IV. REMARKS/ARGUMENTS

A. Amendment to the Drawings

FIG. 6

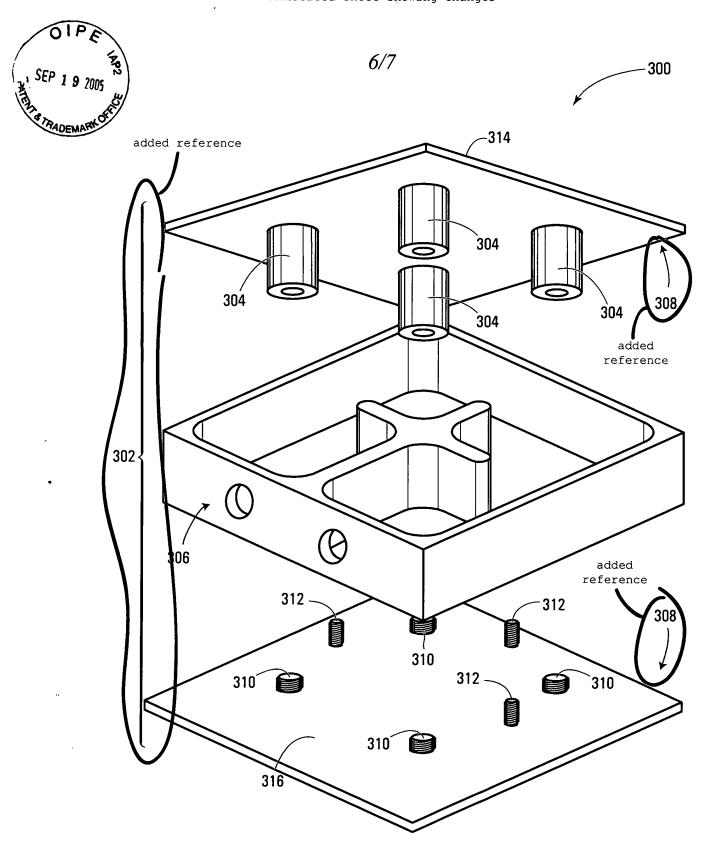
On page 2 of the Office Action, the Examiner indicates that the drawings do not comply with 37 CFR 1.84(p)(5) because they do not include the following reference sign(s) mentioned in the text: 300, 302, 304, 314, 316, 308.

Kindly replace page 6/7 containing old Figure 6 with new page 6/7 containing new Figure 6, enclosed herewith.

In response to the Examiner's objection, the Applicant respectfully submits that Figure 6 has been amended in order to include reference numerals 302 and 308. With respect to reference numerals 300, 304, 314 and 316, the Applicant respectfully submits that these reference numerals were present in Figure 6 as filed. The Applicant further submits that the reference numerals of the third embodiment (p18-19) do match with those shown on Figure 6.
